THE CLEVELAND ELECTRIC ILLUMINATING CO.		PERRY NUCLEAR POWER PLANT		UNIT 1
ELECTRICAL-ELEMENTARY DIAGRAM				
REACTOR CORE ISOLATION COOLING SYSTEM BYPASS MOV				
F076 THROTTLING, OPEN ONLY				
7-23-77	CONSTRUCTION	TEF		
	PRELIMINARY			
	RELEASED FOR	ENGR.		
GILBERT ASSOCIATES, INC. ENGINEERS AND CONSULTANTS				
044549-000	RAM	YGL	DEG	TEF
7-28-77	04	4549	B-208-075	E51 A20 C
DRAWING NUMBER			SYSTEM SH. NO. REV.	
REVB WCR 1299

ELEM DIAG I E51 F076

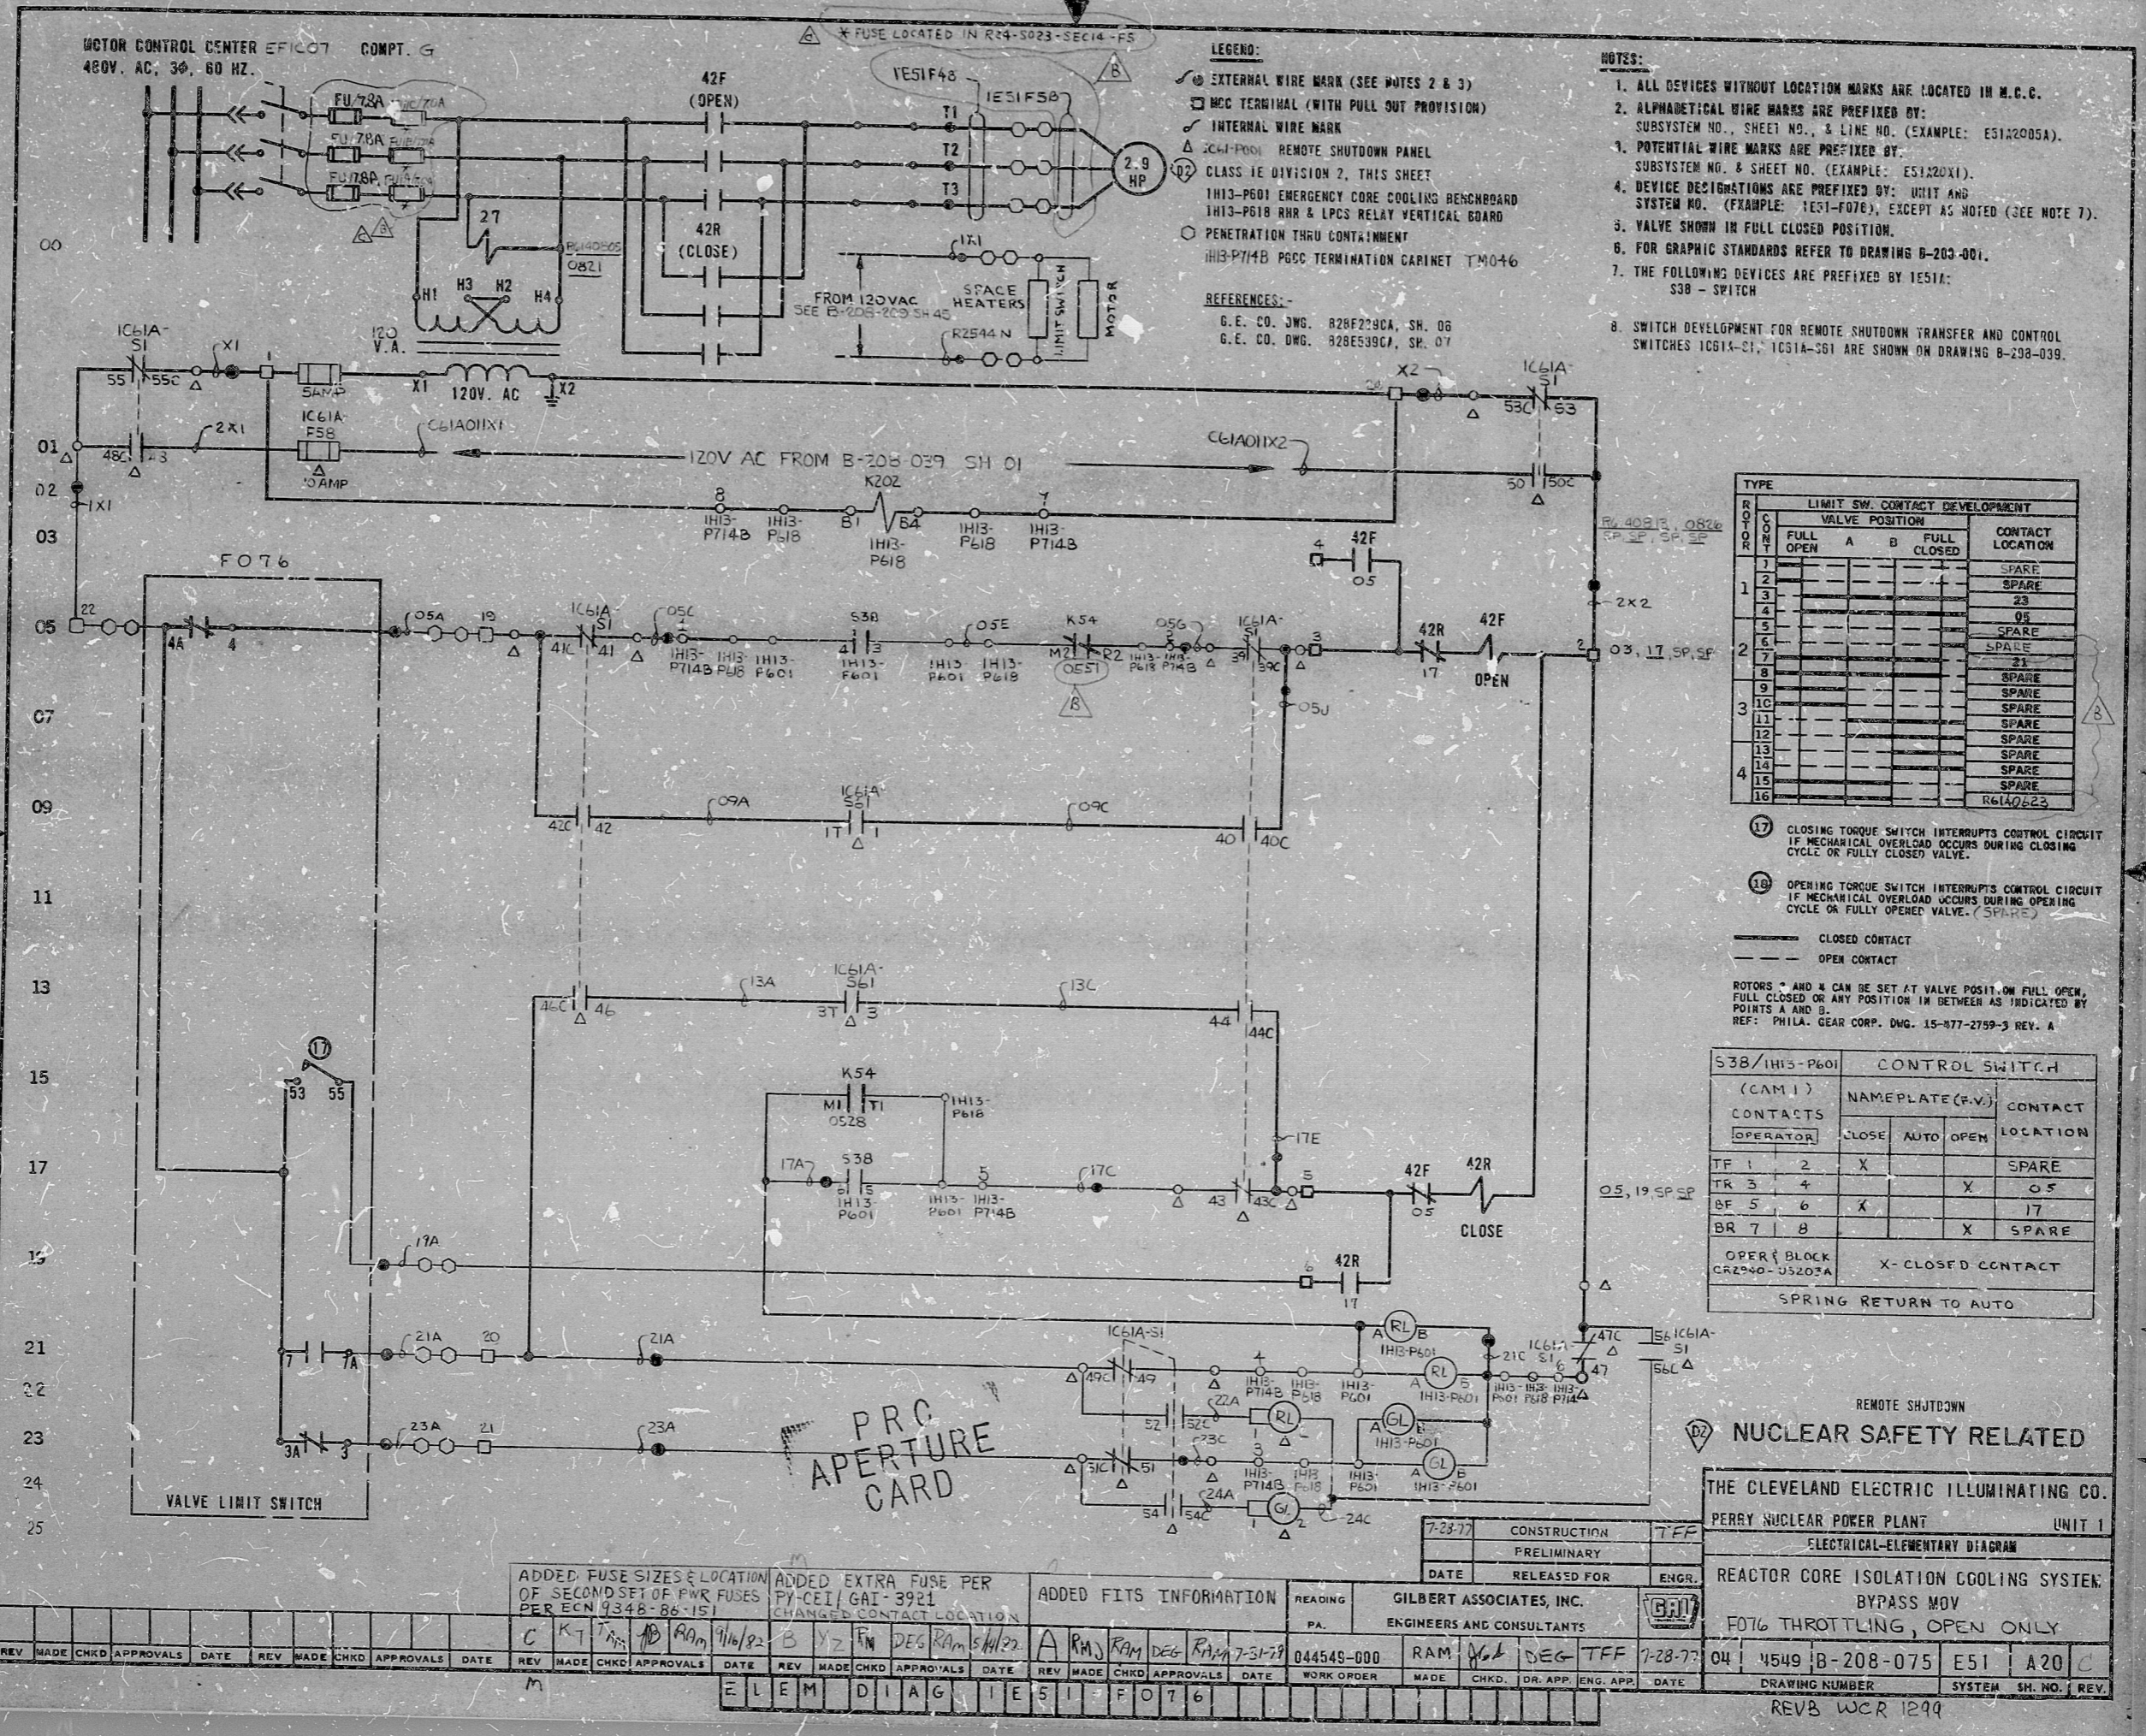
ADDED FUSE SIZES & LOCATION OF SECOND SET OF FWR FUSES PER ECN 934B-88-151

ADDED EXTRA FUSE PER PY-CEI/GAI-3921 CHANGED CONTACT LOCATION

ADDED FITS INFORMATION
